Research Reactor Center
 University of Missouri-Columbia

Reference: Docket 50-186
 University of Missouri – Columbia Research Reactor
 Amended Facility License R-103

SUBJECT: Written communication as specified by 10 CFR 50.4(b)(1) requesting U.S. Nuclear Regulatory Commission approval to amend the Technical Specifications appended to Facility License R-103 pursuant to 10 CFR 50.59(c) and 10 CFR 50.90

Theory of Operation

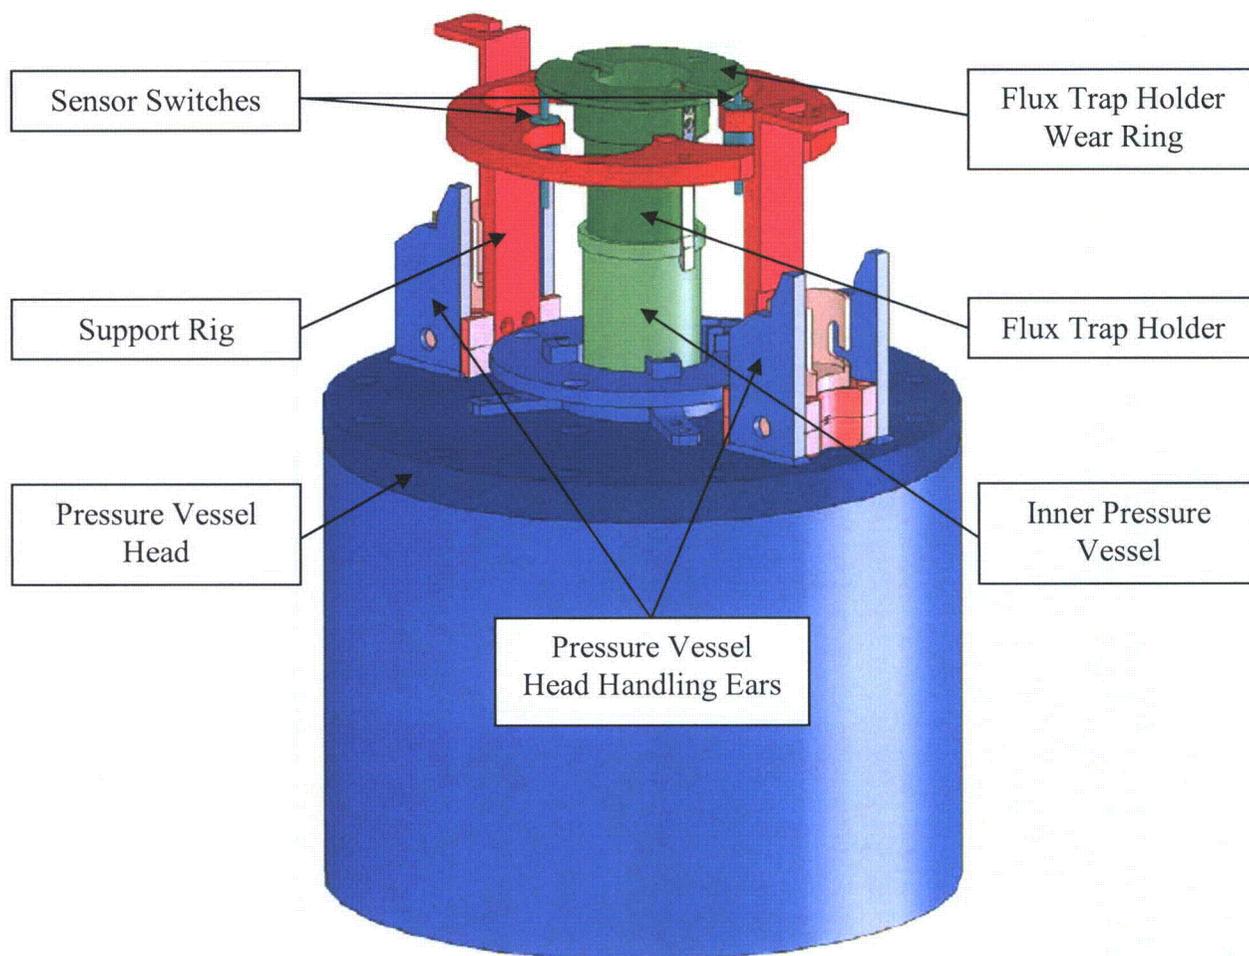
Modification Record 08-5, “Install Temporary Prototype of the Flux-trap Irradiations Reactivity Safety Trip (FIRST) Device,” documented the installation of a testing prototype that was not connected to the reactor safety system. The prototype was installed in December 2008, and tested almost continuously since that time (see “Test” Section).

The FIRST instrument channels will use two independent sensors to detect the position of the Center Test Hole Canister. When a sensor is ‘made-up,’ a relay coil is energized, maintaining a normally open contact in the closed position. This contact is one of several in a series that make up one leg of the 24 VDC input to the reactor safety system. This configuration is duplicated for the other sensor. When a sensor is no longer ‘made-up,’ the relay coil de-energizes, opening a contact, thus interrupting the 24 VDC input signal to the safety system. The resulting trip of the Non-Coincidence Logic Unit (NCLU) will de-energize the Trip Actuator Amplifiers (TAAs) and scram the reactor. This action ensures that if the position of the Center Test Hole Canister or Strainer changes from its secured and latched position, reactor operation will cease. Conversely,

if the sensors are not 'made-up,' the TAAs cannot be reset. This ensures that the Center Test Hole Canister must be installed in order to start up and operate the reactor.

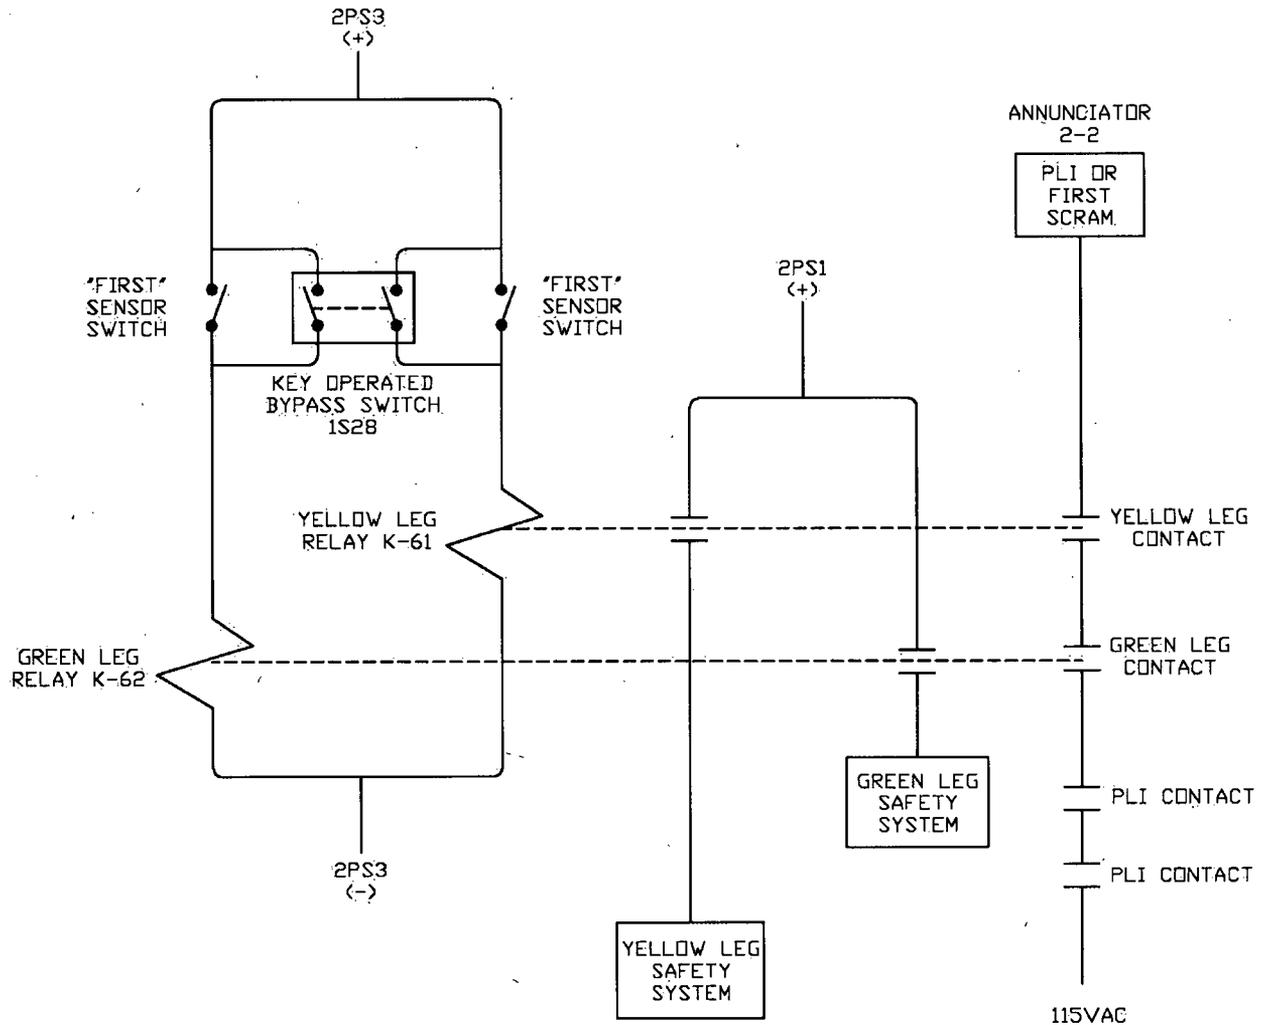
The support rig will attach to the reactor pressure vessel head via the existing vessel head handling ears, and will support and vertically align the two independent switches that close when the Center Test Hole Canister is in its secured and latched position. The support rig will be fabricated from 6061-T6 Aluminum and 304 Stainless Steel and designed using rack and pinion engagement pins to engage the existing handling ears of the pressure vessel head, provide a means to be installed, removed and stored, and allow physical access to all bolts of the pressure vessel head should the device prove unable to be disengaged and removed underwater. The rack and pinion engagement pins will be operated using a 2-inch rotating rod (a common handling tool in the pool), and will have opposed direction of rotation to counter any induced moment.

The switches will be adjustable in height, held in place using jam nuts, and be provided protective collars to prevent over travel of the switches. This condition would only occur in the event of improper handling or improper installation of the support rig.
